Subject: Response to U.S. EPR Design Certification Application RAI No. 547 (6499, 6359), FSAR Ch. 3 - NEW PHASE 4 RAI, Supplement 6 - Part 1 of 4
Sent Date: 4/29/2013 5:18:22 PM
Received Date: 4/29/2013 5:20:57 PM
From: WILLIFORD Dennis (AREVA)

QUESTIONS for Structural Engineering Branch 2 (ESBWR/ABWR Projects) (SEB2)

Question 03.07.02-78**Open Item****Follow-up to RAI 371, Question 03.07.02-66 and RAI 376 Question 03.08.05-28.**

Figure 3.7.2-78-1: Shell to Solid MPCs for Tendon Gallery and Basemat Connection

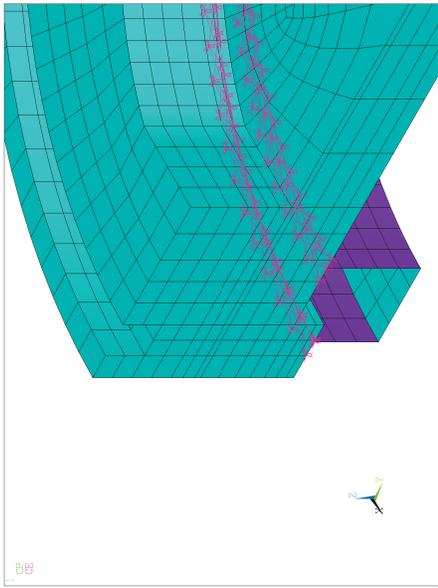
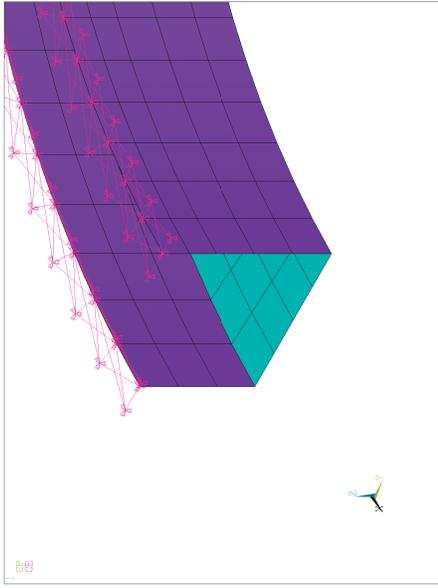
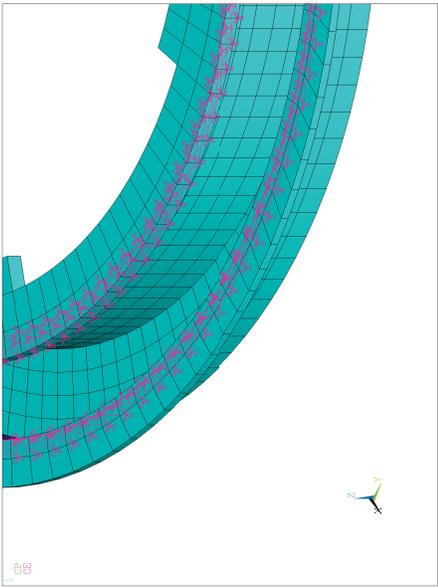
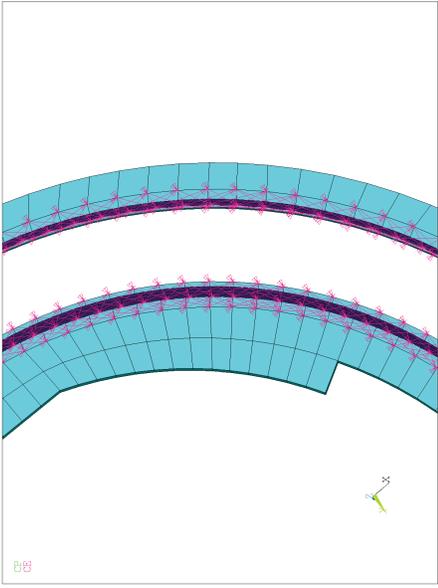
The tendon gallery acts as a shear key under seismic loads. The seismic loads need to include the effect of any localized movement of the basemat. Determining the additional loads due to movement of the basemat is accomplished by performing two separate analyses. In the first analysis, uplift and sliding of the basemat is not allowed. In the second analysis, uplift and sliding is permitted. The difference in the pressure between these two cases is a delta pressure which is added to the lateral loads determined from the SASSI SSI analysis of the NI. For the two rock cases which appear to provide the highest sidewall pressure loads on the shear key, the applicant states that the top ring of nodes of the tendon gallery are connected to the solid element basemat using ANSYS shell to solid Multi-Point Constraints (MPCs) and have no sidewall rock springs. The bottom ring (elevation) of nodes of these shell elements that are connected to the basemat have stiff sidewall rock springs that simulate partially fixed boundary conditions. These nodes experience higher pressures and moments (stress concentration effect) typically associated with fixity. For these cases, average maximum pressure values considering a full element instead of a node are presented in Table 03.07.02-66-2. As it is not clear from the applicant's explanation which nodes or elements are being described and what is meant by partially fixed boundary conditions, the applicant is requested to provide:

- A figure depicting the boundary conditions for the shear key nodes and;
 - A figure depicting maximum pressure values and average pressure values over the complete height of the tendon gallery with a description of how the average values were calculated.

- The TG walls are modeled using shell elements (ANSYS SHELL43 elements) and connected to the solid element basemat (ANSYS SOLID45 elements) using ANSYS shell to solid Multi-Point Constraints (MPCs). Figure 3.7.2-78-1 shows the shell to solid MPCs. The bottom of the NI basemat solid elements is located at different elevations. The outer TG walls connect to the Balance of Nuclear Island portion of the NI common basemat at elevation -41ft and the inner TG walls connect to the RBIS/RCB portion of the NI common basemat at elevation -36 ft. Table 3.7.2-78-8 lists the nodes at different elevations of the TG and their boundary conditions.

Figure 3.7.2-78-3: Case 2sn4uem, Cracked, Additional (Delta) Pressures Due to Sliding on the Tendon Gallery Walls

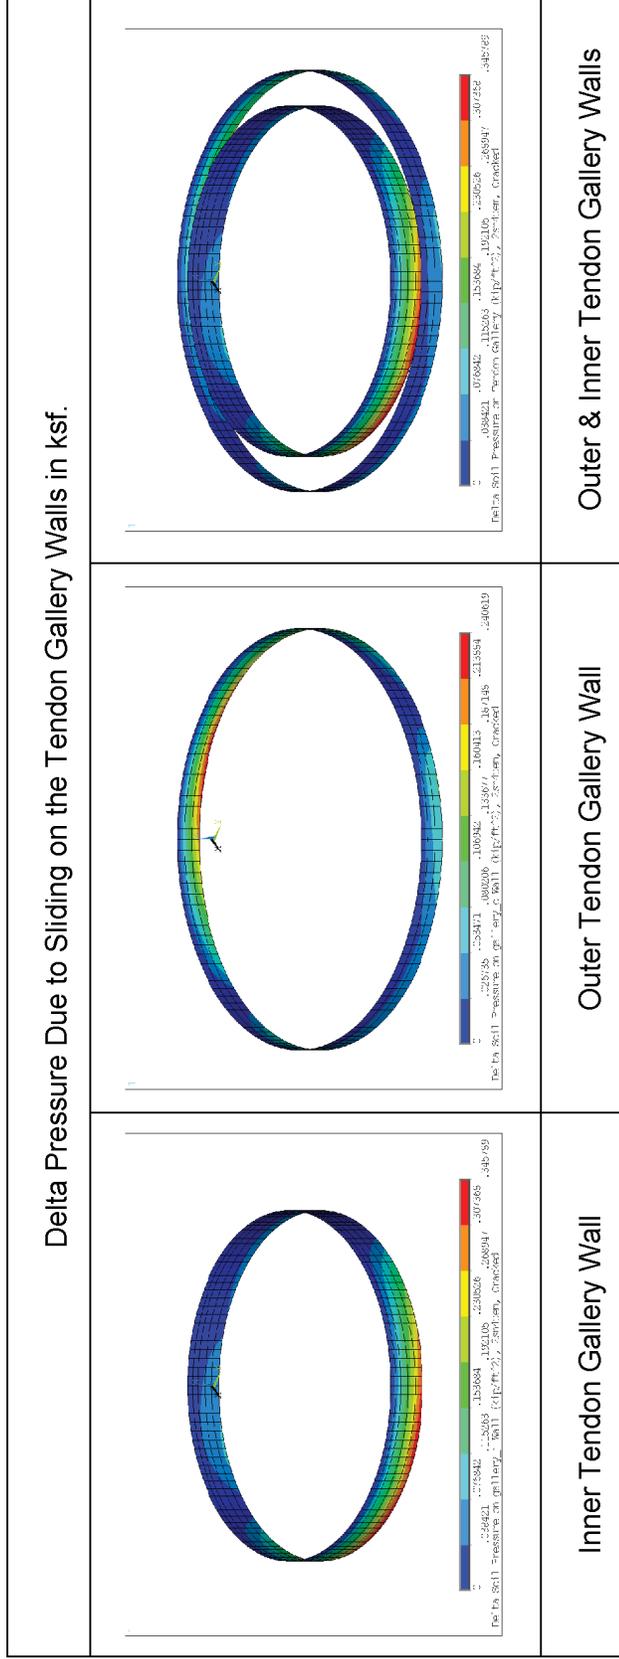
- (d) It appears that the additional pressures due to the localized sliding/uplift of the basemat (i.e., the “delta pressures” described in the response to RAI 371 Question 03.07.02-66, listed in Tables 03.07.02-66-1 and 03.07.02-66-2) were not included in the referenced figures in RAI 376 Question 03.08.05-28. It therefore does not provide the staff with an accurate representation of the total soil pressures acting on the walls, which was the intent of the original RAI. Therefore, the applicant should provide a revised version of the figures in RAI 376 Question 03.08.05-28 that includes the SSI pressures, the delta pressures, and the combination of the two for all embedded walls including the tendon gallery. The information provided should be consistent with the information requested under Question (1) of this RAI.

Figures 3.7.2-78-2 through 3.7.2-78-6 show the delta pressures on TG walls due to sliding for soil cases 1n2ue, 2sn4uem, 4uem, 1n5aeh and 5aeh, respectively. Table 3.7.2-78-9 lists the delta pressures on the TG walls for the soil cases 1n2ue, 2sn4uem and 4uem.
